Rezoning Application: PD 25-1382
Zoning Hearing Master Date: February 23, 2026
BOCC Land Use Meeting Date: April 07, 2026

Development Services Department

The proposed zoning is for Planned Development (site plan controlled district) to allow a 4,295 SF Dance Studio; pursuant to the development standards in the table below and site plan depicted in 2.4 of the report within the existing building.

AGENCY REVIEW COMMENT SHEET

8.0 PROPOSED SITE PLAN (FULL)

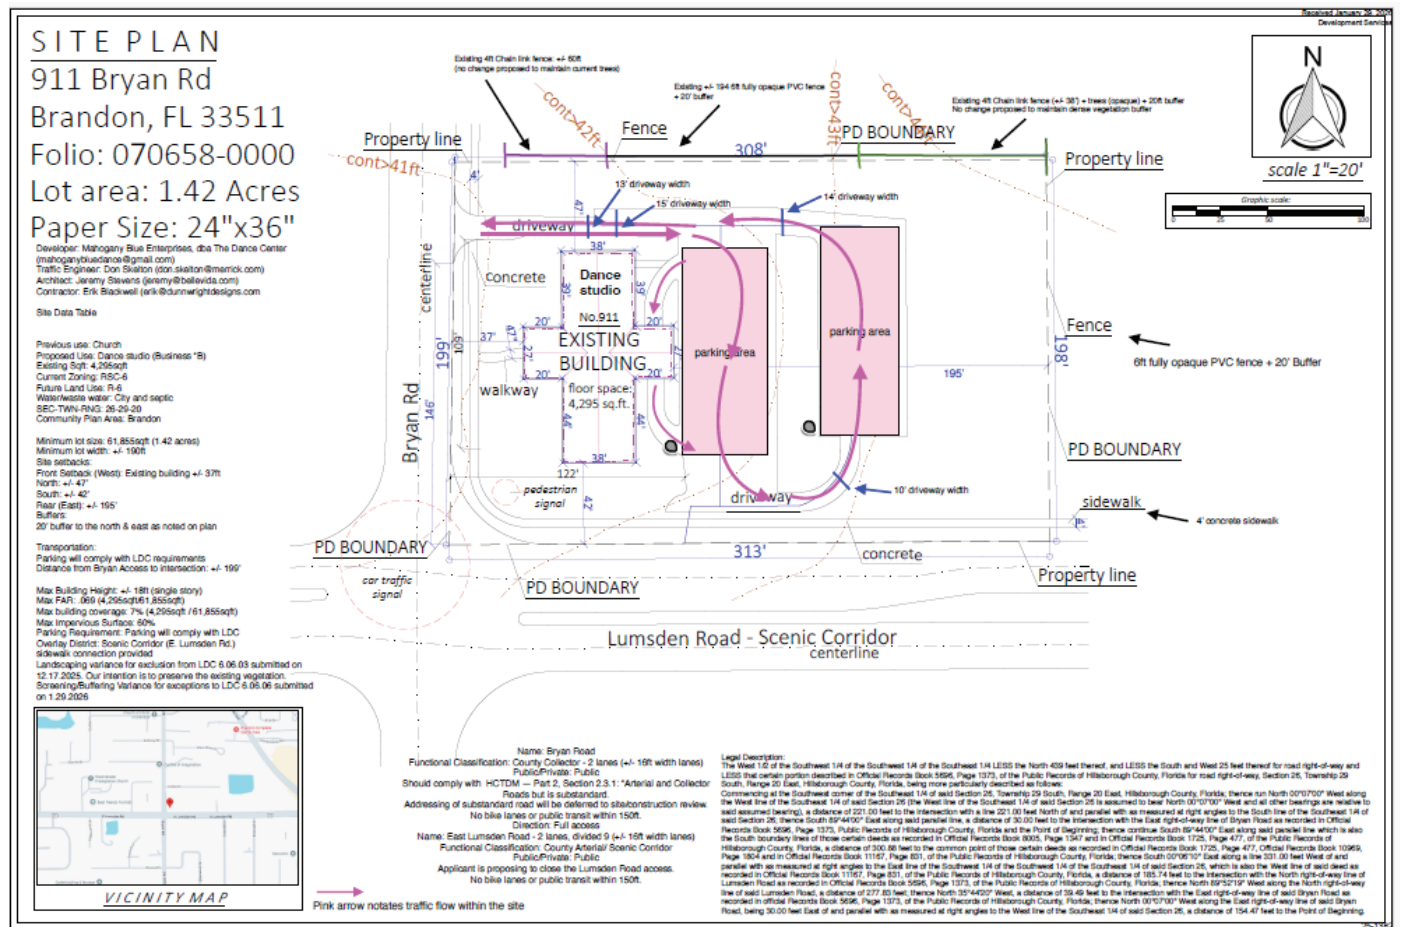
Prior to PD Site Plan certification, the developer shall revise the PD site plan to:

Change the Proposed Use under the Site Data Table to reflect the LDC Article II terminology for the proposed use (Recreational Uses, General Indoor).

- 3.1 Along the northern boundary, a minimum 20-foot-wide buffer shall be provided. Existing vegetation shall be preserved, unless otherwise directed to be removed by Natural Resources. A 4-foot-high chain-link fence shall be provided along the western and eastern portions of the northern boundary, and a 194-foot-long 6-foot high fully opaque PVC fence shall be provided along the central portion of the northern boundary, as depicted on the site plan.

- 3.2 Along the eastern boundary, a minimum 20-foot-wide buffer shall be provided with the preservation of existing vegetation (unless otherwise directed to be removed by Natural Resources), and a 6-foot-high fully opaque PVC fence shall be installed, as shown on the site plan.

4.The development shall be served by and limited to one (1) full-access connection to Bryan Road as shown on the PD Site Plan. Such access may be restricted in the future due to safety or operational considerations. The developer shall close the existing access to E Lumsden Road and restore curbing, sod, and sidewalks, as necessary.
